## MEMORANDUM

**To:** Planning Board  
**FROM:** Sloane Walbert, Case Manager  
**DATE:** August 17, 2015  
**SUBJECT:** **Call Up Item:** Approval of a Minor Amendment to Approved Site Review to convert six one-bedroom units into a new community center at 3502 Nottingham Ct. (Kalmia Apartments), which includes the addition of 588 square feet on two levels. Included in the approval are new porches and decks on all ten buildings, new storage sheds for all units, updated landscaping and a relocated playground. In addition, the drive access between Nottingham Ct. and Arthur Ct. will be converted into a one-way pedestrian-oriented street. The project site is zoned Residential – High 4 (RH-4). Case No. LUR2015-00023.

# BHP - Kalmia

**1** DETAILED GRADING PLAN  
 SCALE: 1" = 10'

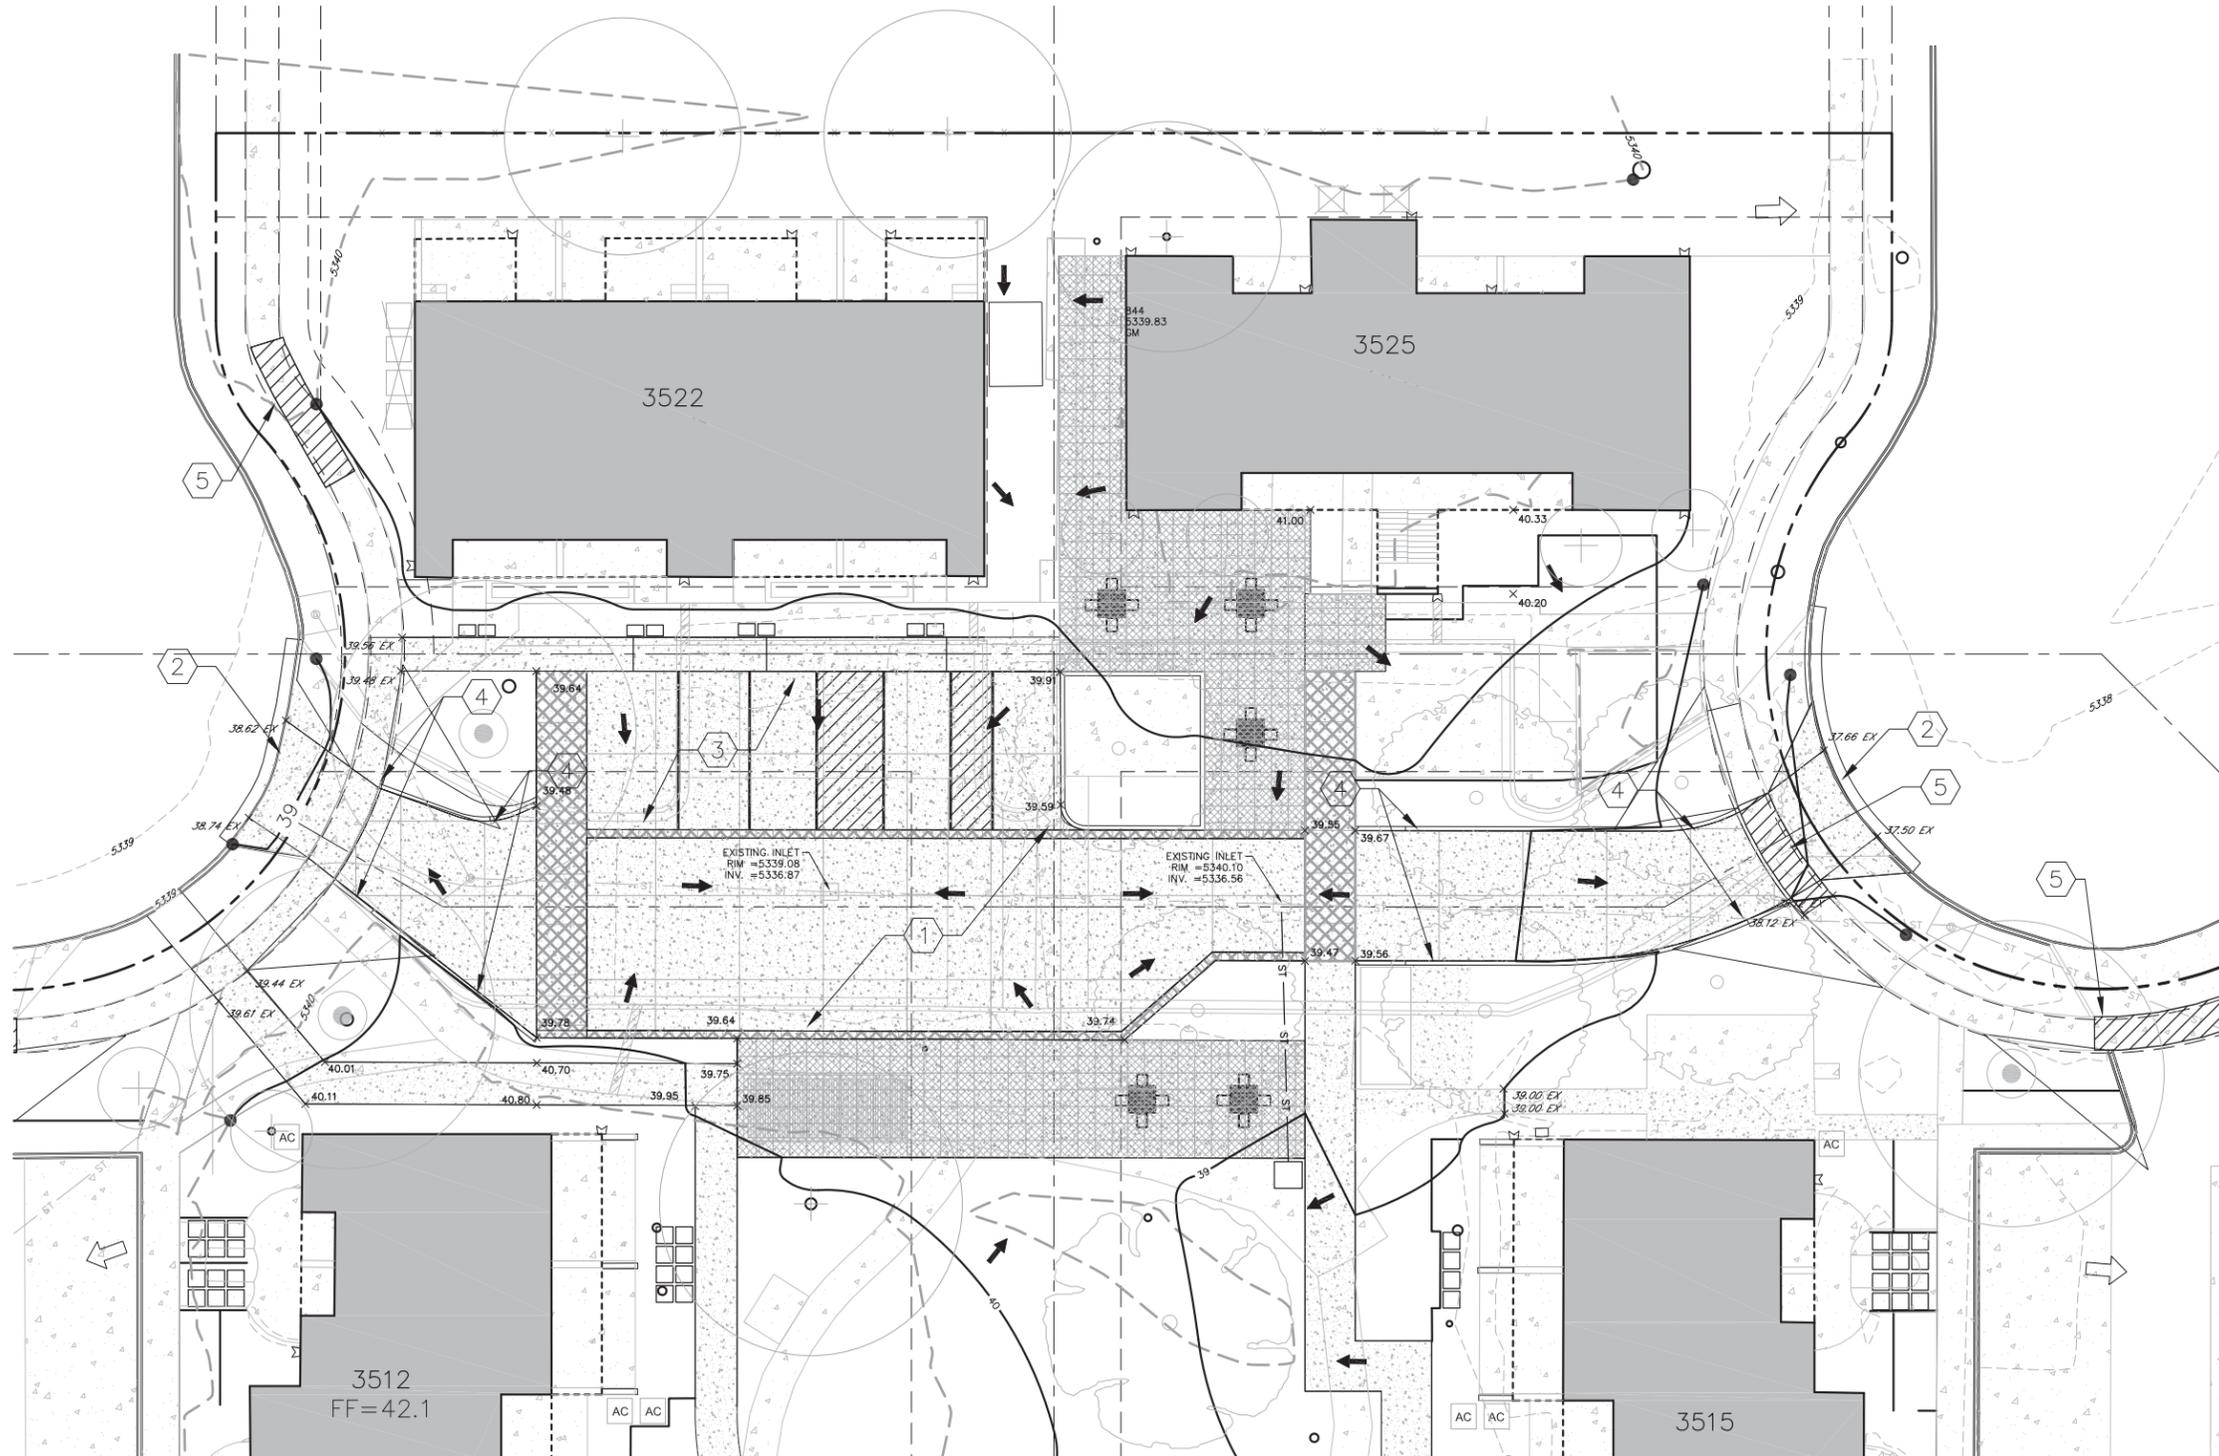
**Response:** In light of the requirements in comment 1, we have eliminated the collective bike shelter in lieu of providing long term parking at each individual unit shed.
3. Please revise the site plans to show the specific design elements of the proposed woonerf. Sheet 1.01 states "construct new woonerf-style streetscape with shared space and traffic calming devices." Please elaborate with detailed plans. Staff recommends using colored pavers to delineate the bus pull out and parking stalls. In addition, the applicant should consider constructing a raised crosswalk with distinct pavers and/or reducing the width of the curb cut (driveway) in order to reduce vehicle speeds at the access points.

**Response:** See provided enlarged landscape plan for Woonerf style street layout & details. Sheet L102.
4. Please revise the site plans to show the replacement of sidewalk along Nottingham Ct. and Arthur Ct. meeting the criteria for sidewalk replacement as described in [section 8-2-17\(b\)](#) of the B.R.C. Please contact staff to obtain the limits of the sidewalk replacement along Nottingham Ct. and Arthur Ct.
